ADDENDUM NO. 3

November 11, 2022

LIBERTY ELEMENTARY SCHOOL RENOVATIONS Chesterton, IN 46304

DRAWING
UNIT "A" FIRST FLOOR
REFLECTED CEILING PLAN

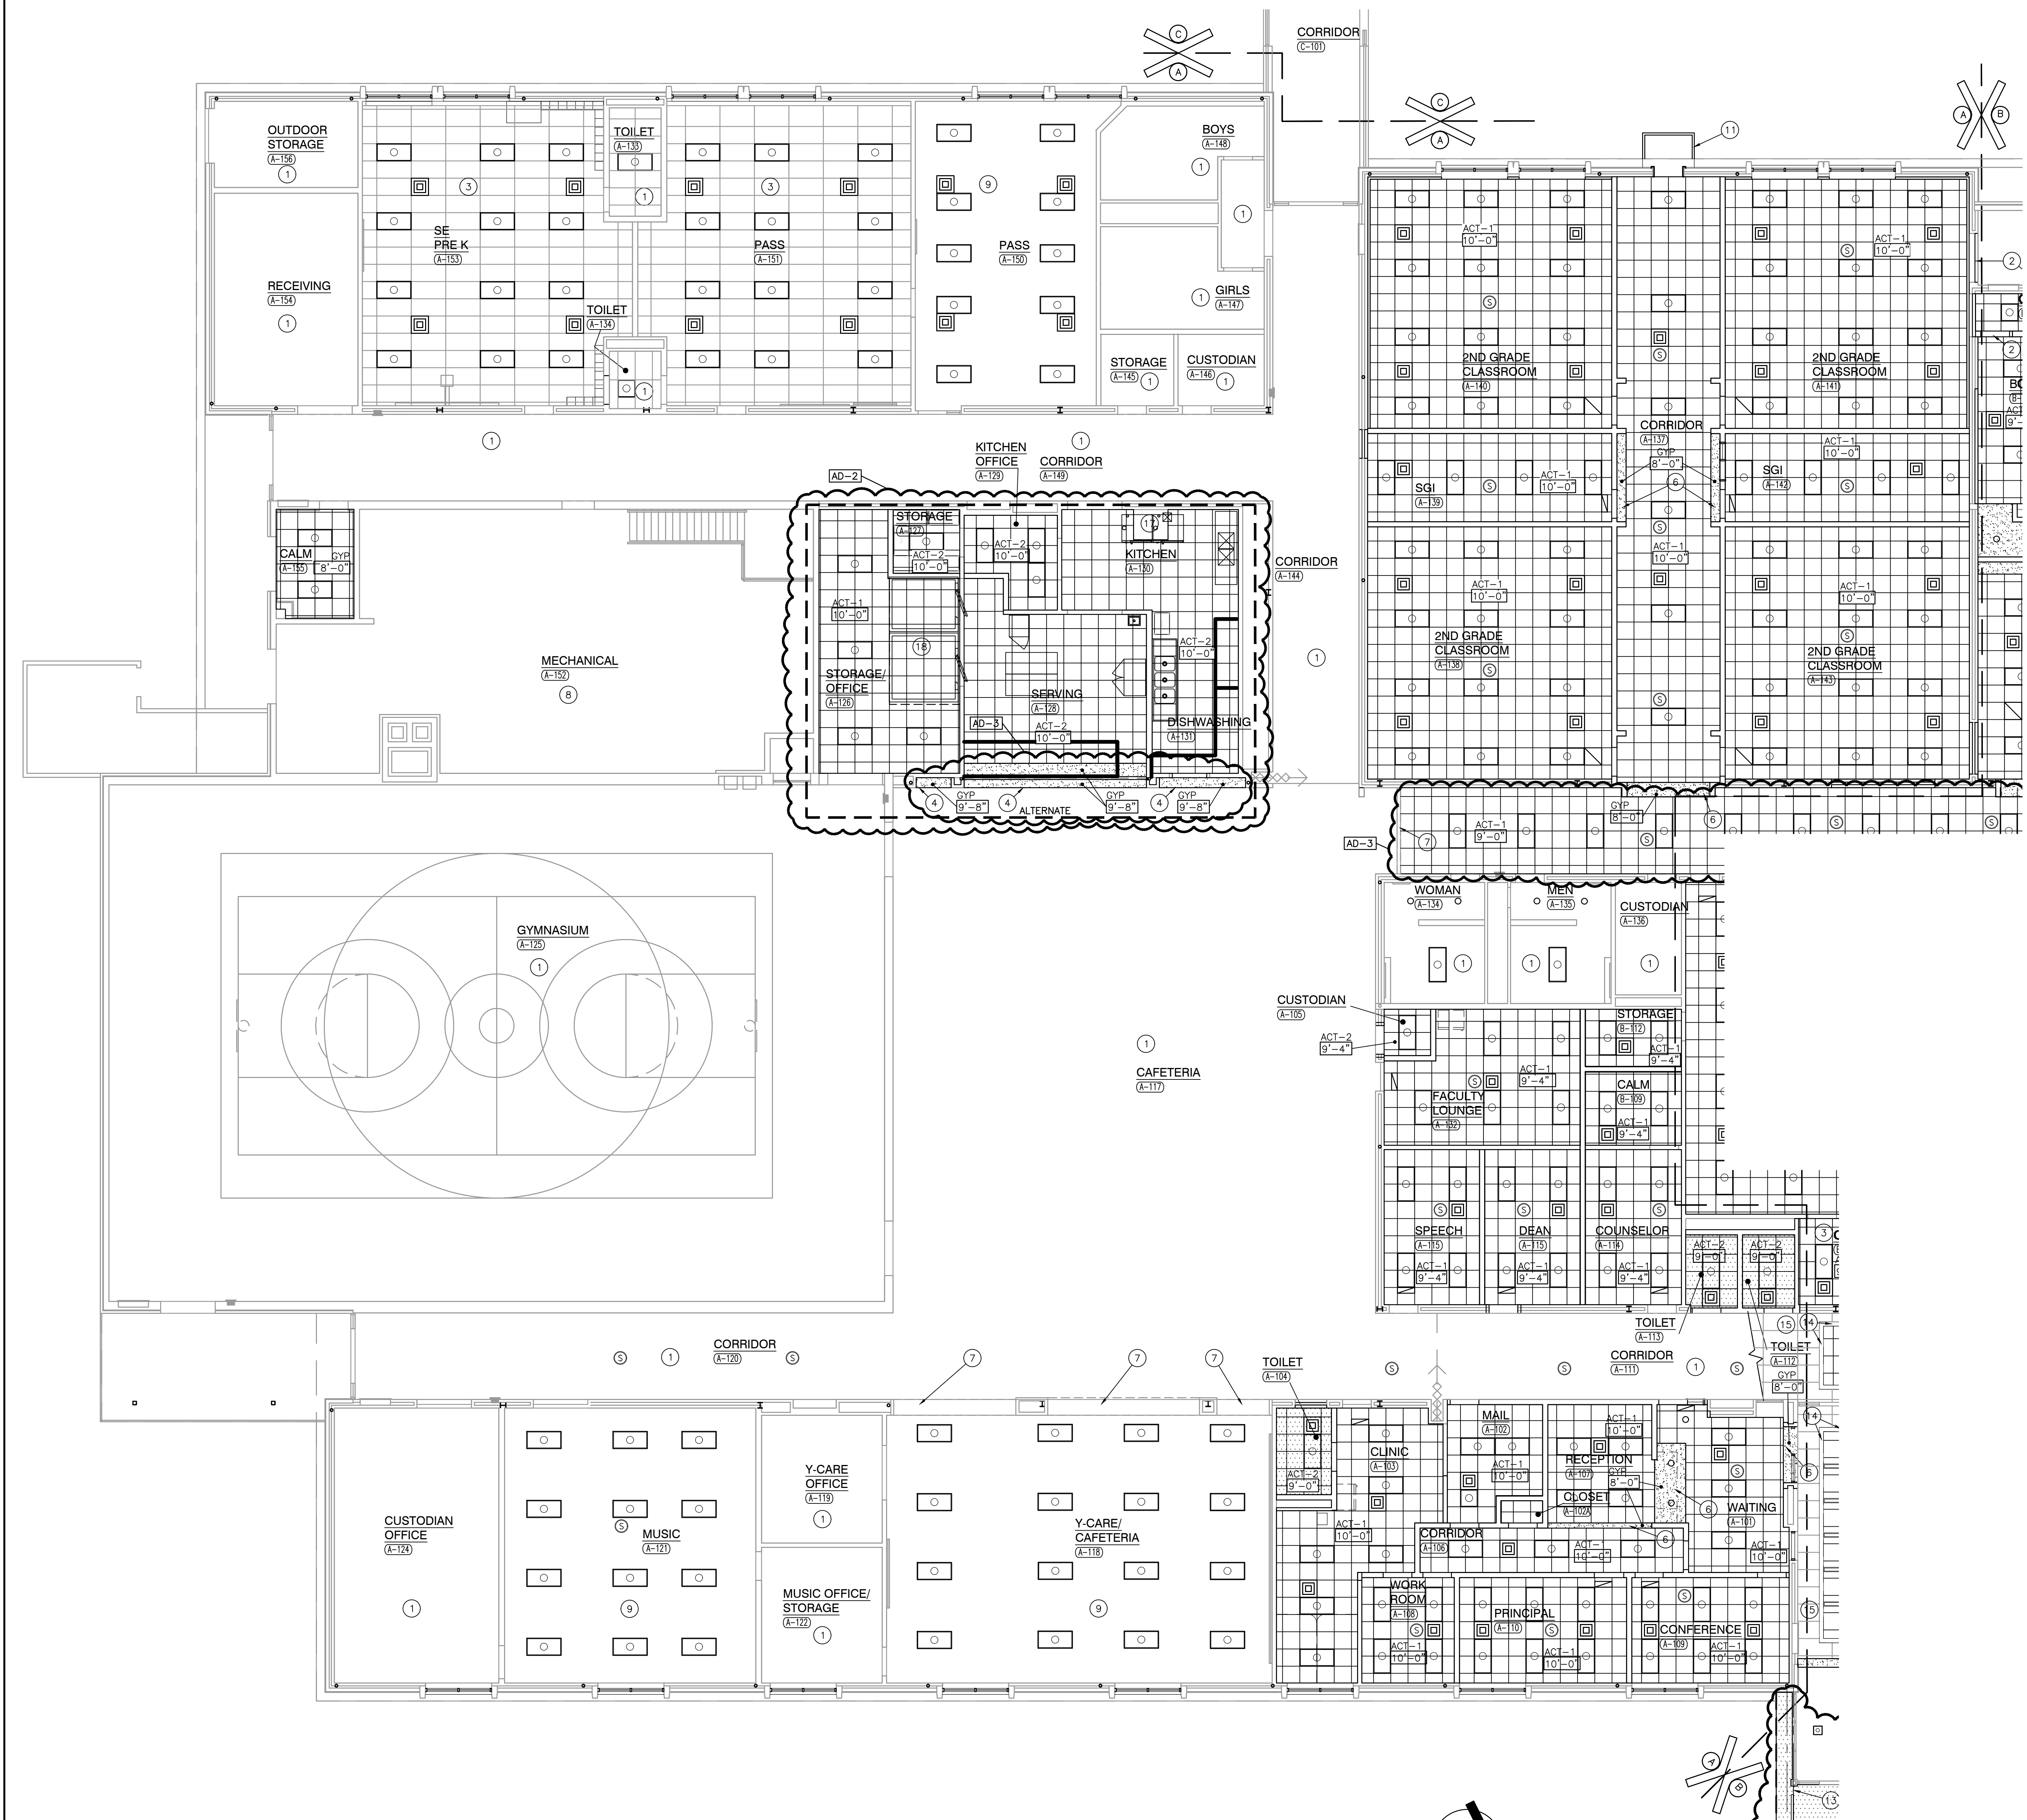
- A. Refer to revised full size drawings, included in this Addendum, for the following revisions:
1. Add Reflected Ceiling Plan Notes 21 and 22.
 2. Add new bulkheads between Cafeteria A-117 and Serving A-128.
 3. Add new ceilings to corridor north of Restrooms A-134 and A-135.

UNIT "B" FIRST FLOOR
REFLECTED CEILING PLAN

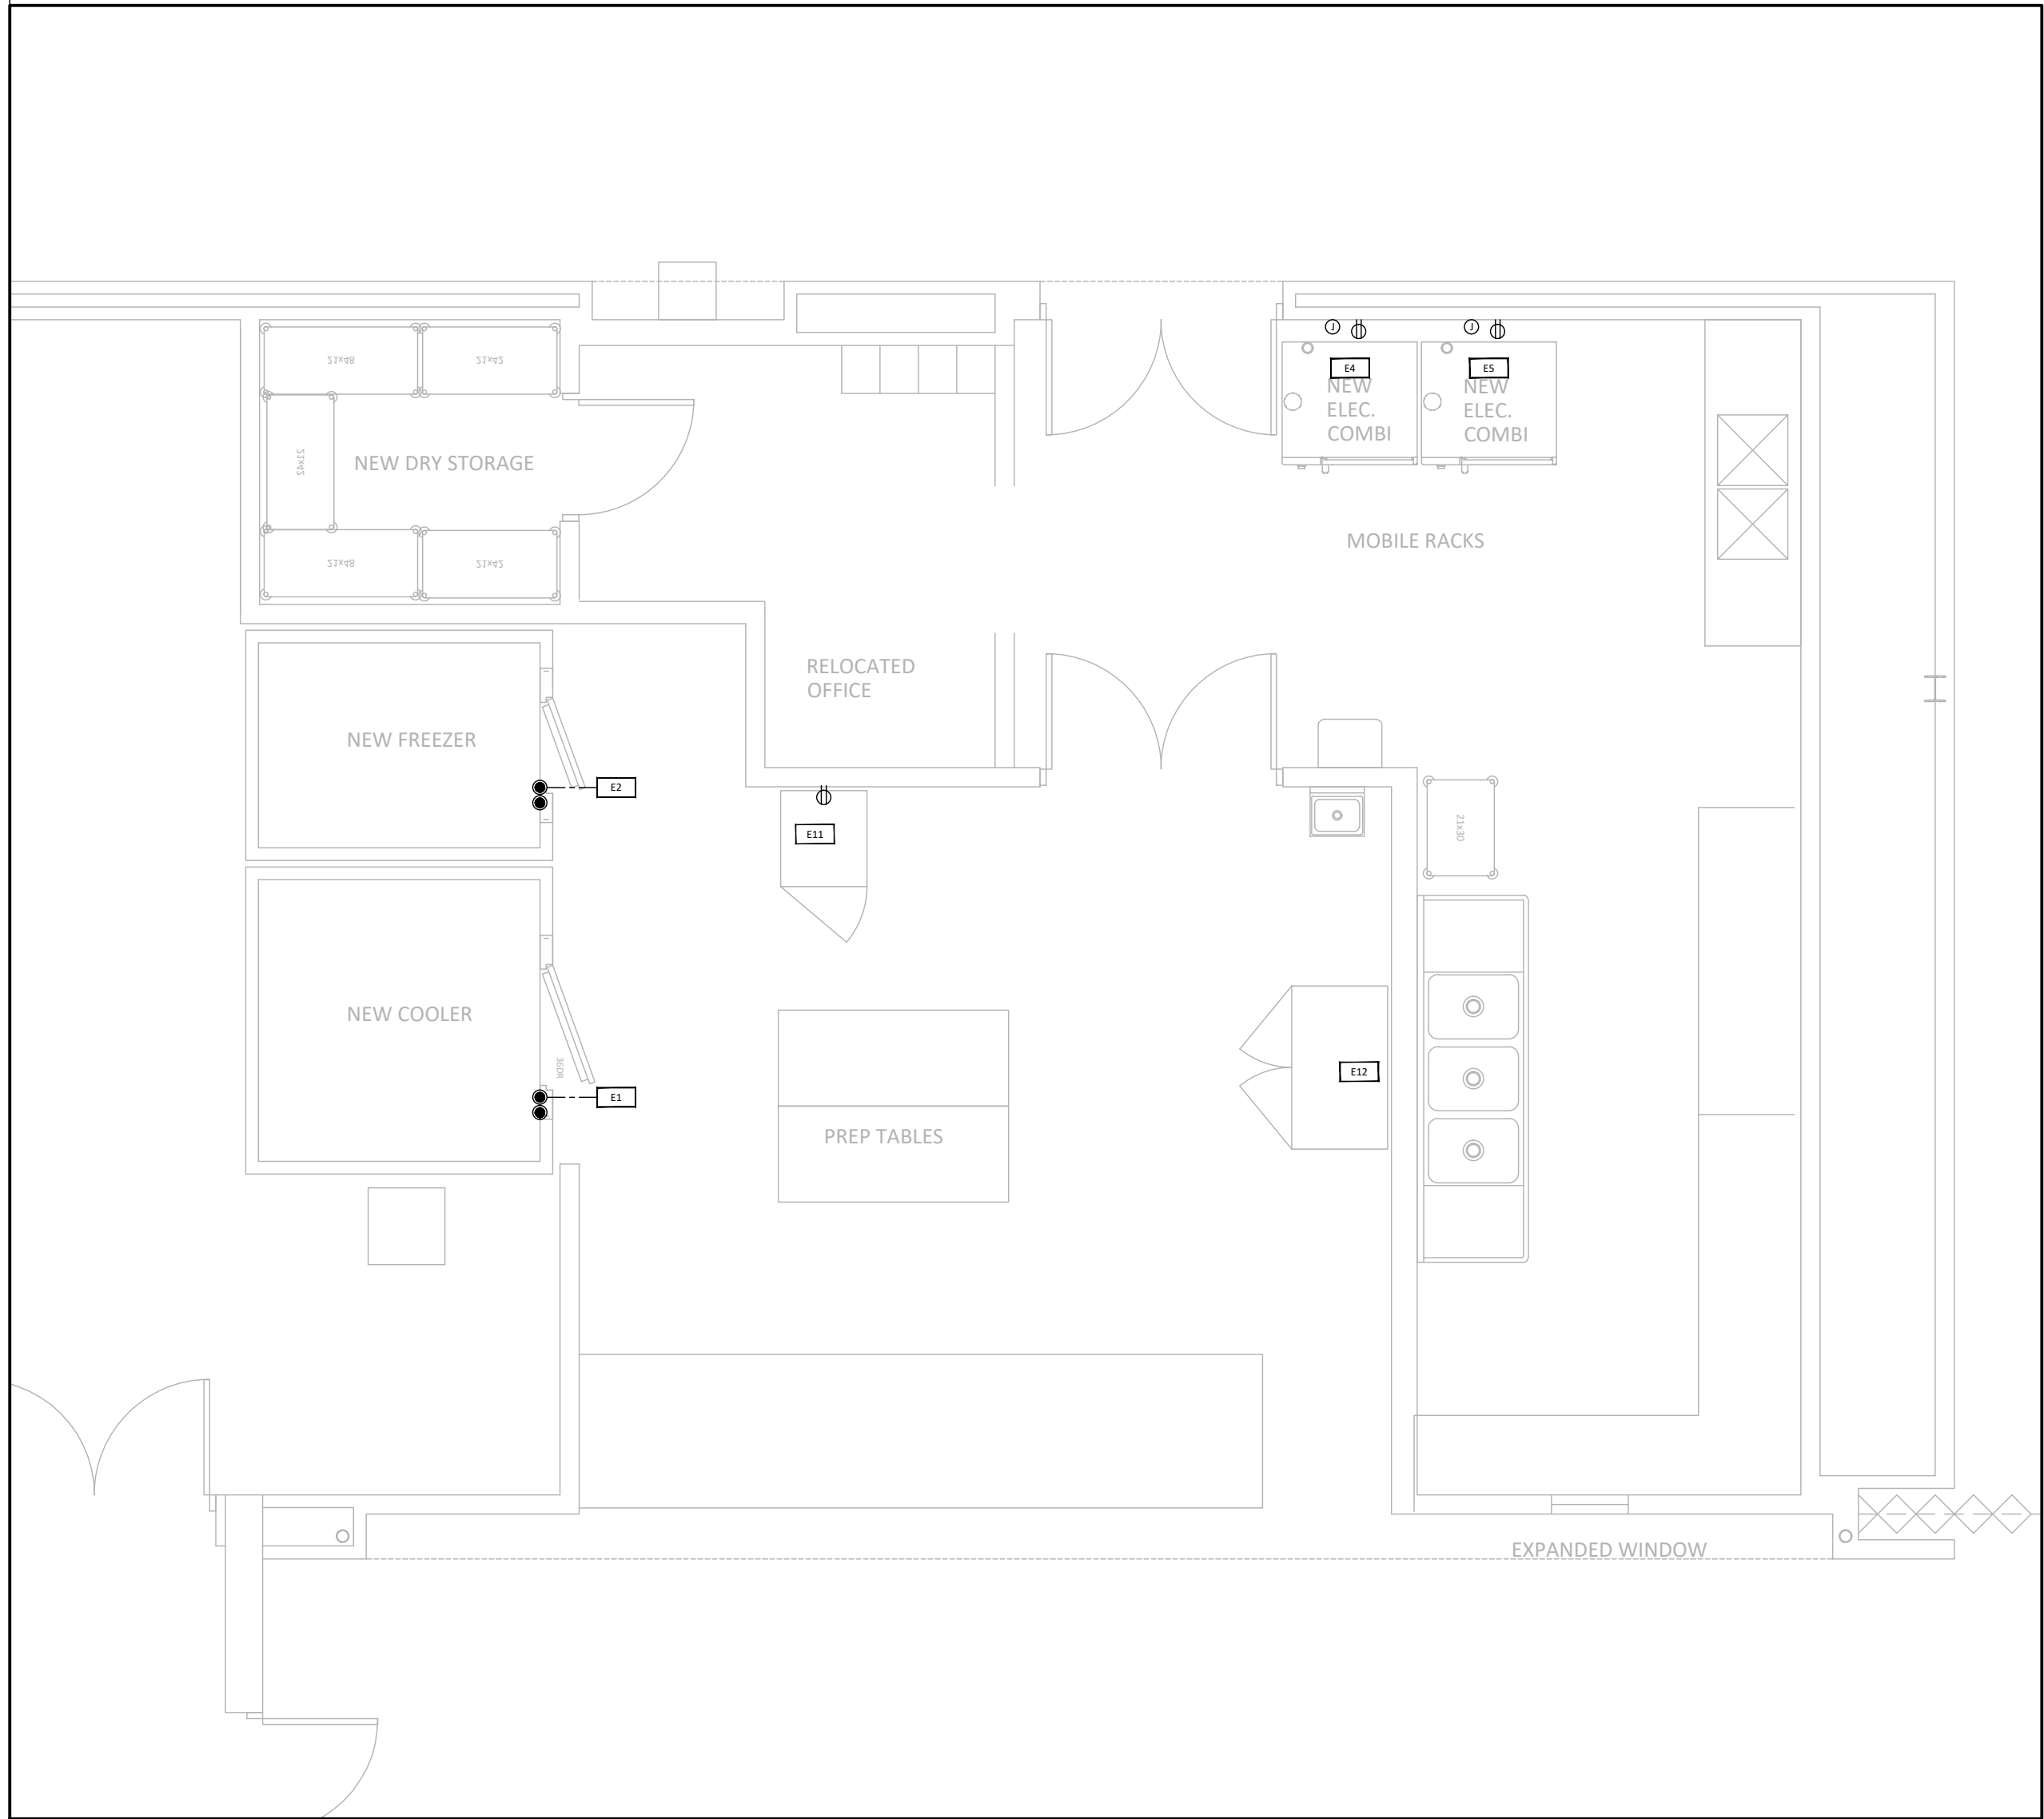
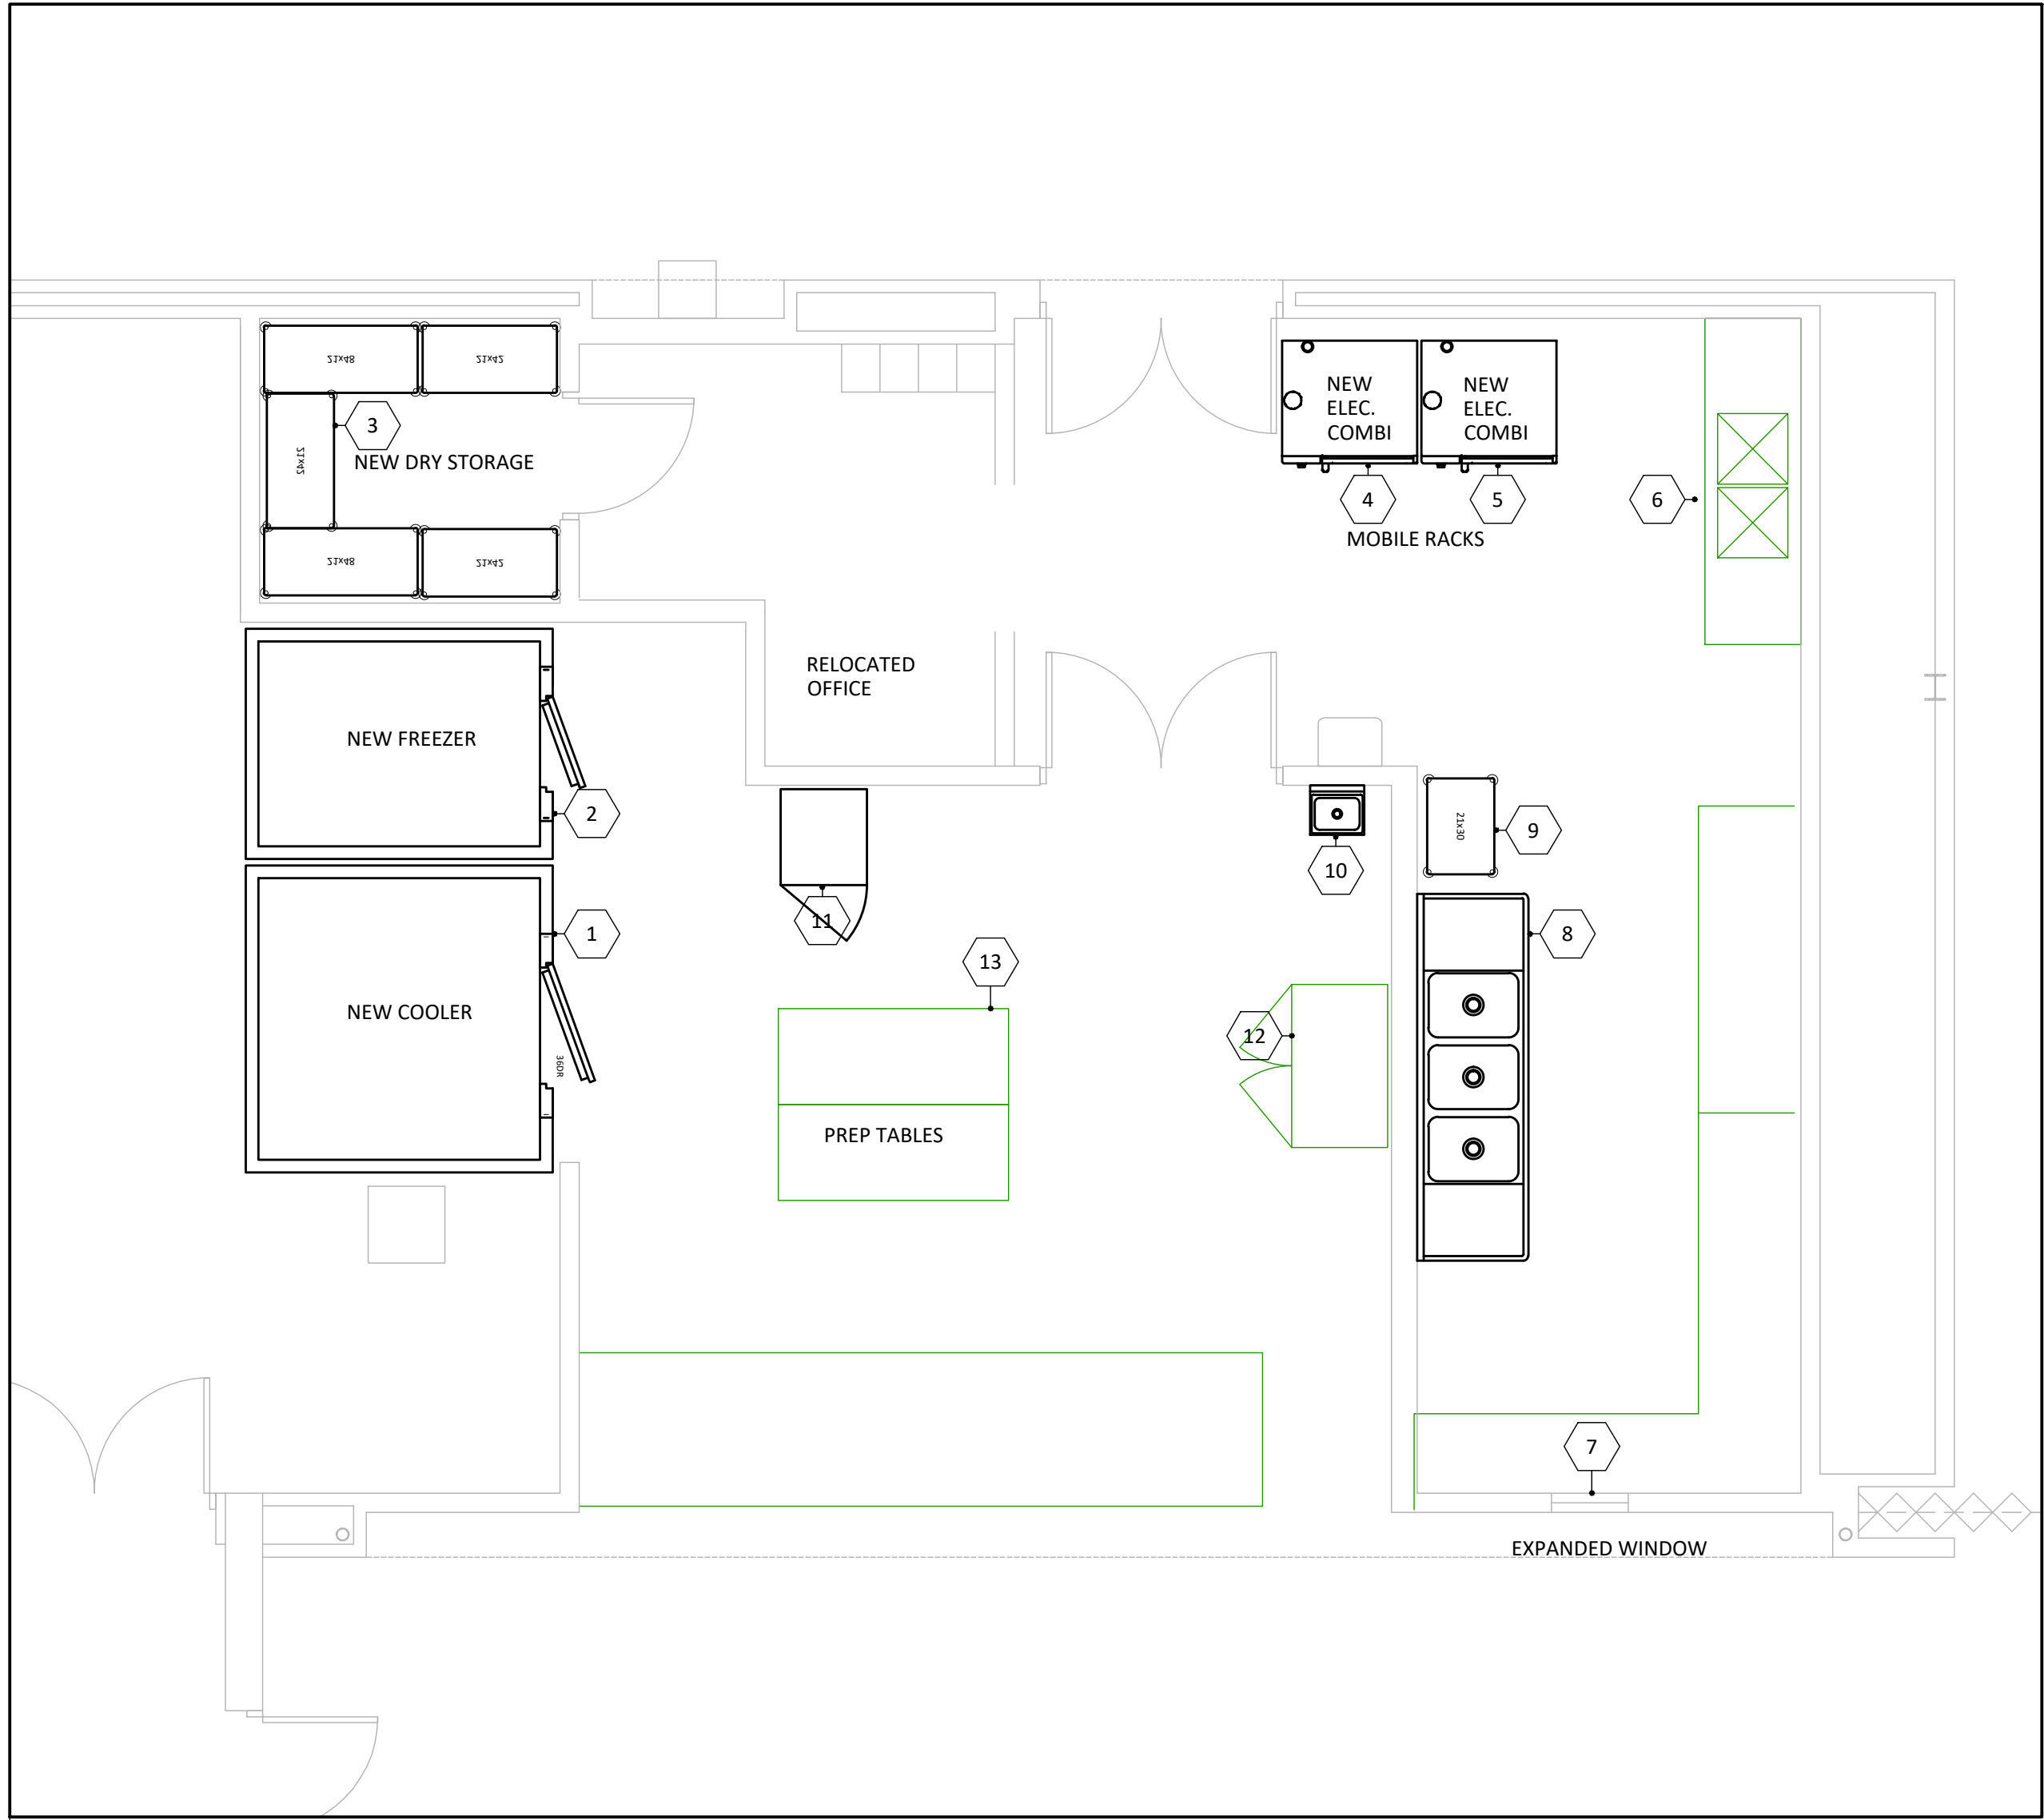
- A. Refer to revised full size drawings, included in this Addendum, for the following revisions:
1. Add Reflected Ceiling Plan Notes 21 and 22.
 2. Add new ceilings to Media Center B-107 and surrounding Corridors.
